ERCOT Independent Review CenterPoint (CNP) Dynamic Reactive Project July 14, 2006

Appendix 1
REVIEW OF CENTERPOINT'S
HOUSTON AREA DYNAMIC REACTIVE
PROJECT
2007 SUMMER PEAK NETWORK CONDITIONS

Simulation 1: Plot of voltage output of all generators in the Houston Area, with retired/mothballed units in.

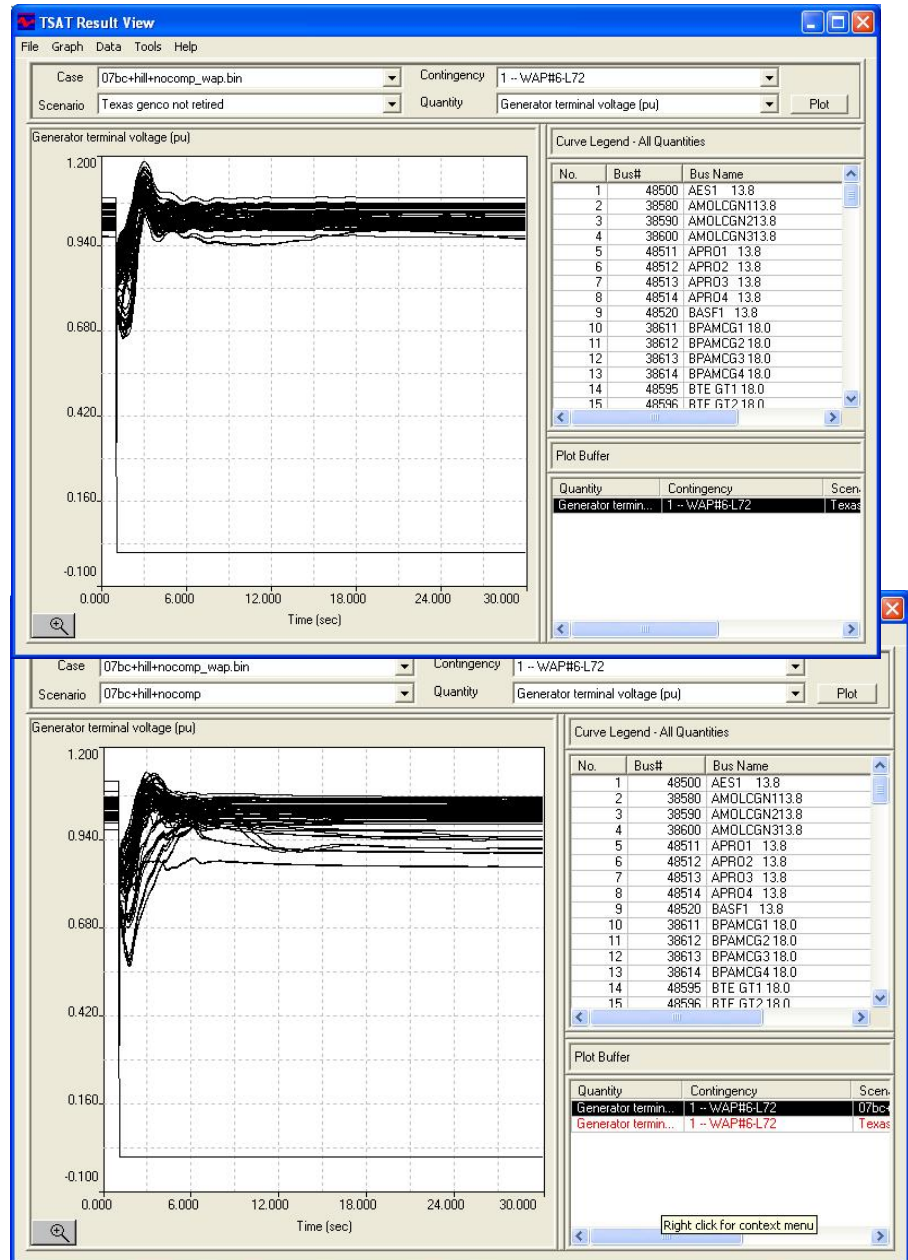
Retired/Mothballed units were included in the first run and then taken out again in the second run, without adding any dynamic device to the case. These runs show the dynamic vars contribution of the retired/mothballed units to the Houston Network and how the decommissioned units results in voltage collapse for the test of the NERC category D contingency.

All generators with terminal voltage levels higher than 0.9 p.u.
